Vegetation Management in Caltrans Highway 1 right-of-way in Montara

Midcoast Community Council March 14, 2018

Desired outcome: Affirm community priorities to preserve and enhance **public ocean views** and **bike/pedestrian safety and mobility** on Highway 1 in Montara, including a list of **Caltrans vegetation maintenance tasks** to further these goals.

General practices:

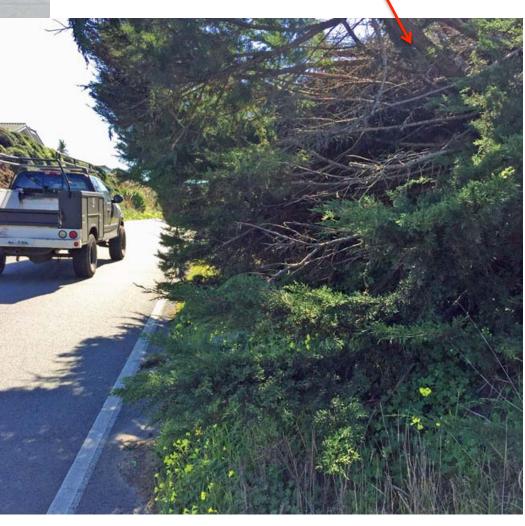
- Maintain open sight line 10 ft from hwy. Prune lower tree branches back to trunk to clear the shoulder area and avoid regrowth or unsightly dead branch stubs.
- Remove tree seedlings that volunteer at road edge to avoid expensive future maintenance of large trees in unsuitable locations. Monterey cypress, a 40x40 ft tree, should be no closer than 20 ft to hwy.

4th to Montara State Beach lot

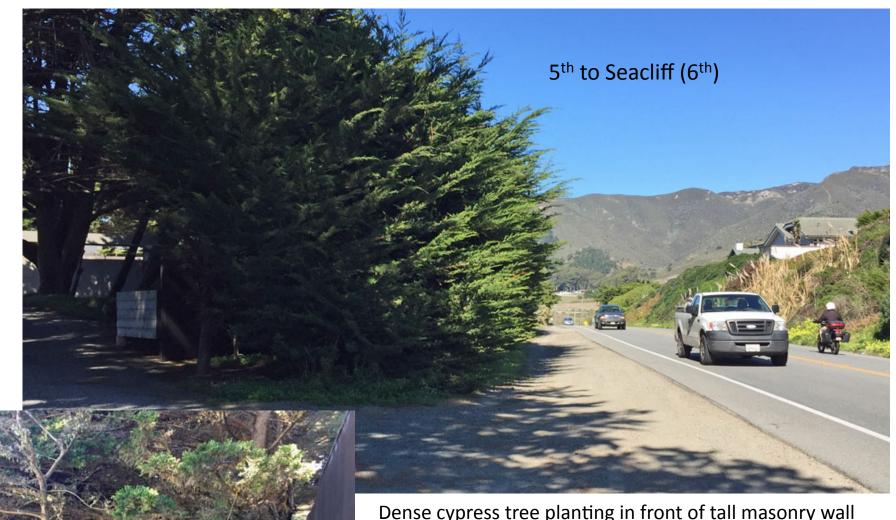
At 4th St, remove Arundo donax (giant reed) -- spreading, invasive weed

Longer term consideration: Avoid this narrow shoulder segment and bring hikers up to the ocean view, by grading pedestrian trail access at 4th, and pruning lower cypress branches along top of road cut, to connect trail to Montara Beach parking lot. Would involve State Parks and DPW in addition to Caltrans.

10th St. maintenance

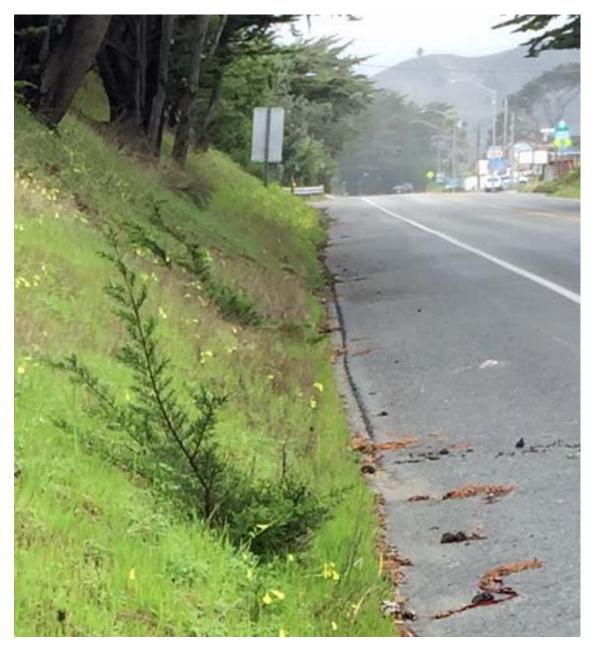
Remove 3 small dead staked cypress trees from view corridor.

Prune encroaching lower cypress branches off at the trunk, instead of stub cuts, which quickly regrow, or die and look unsightly.
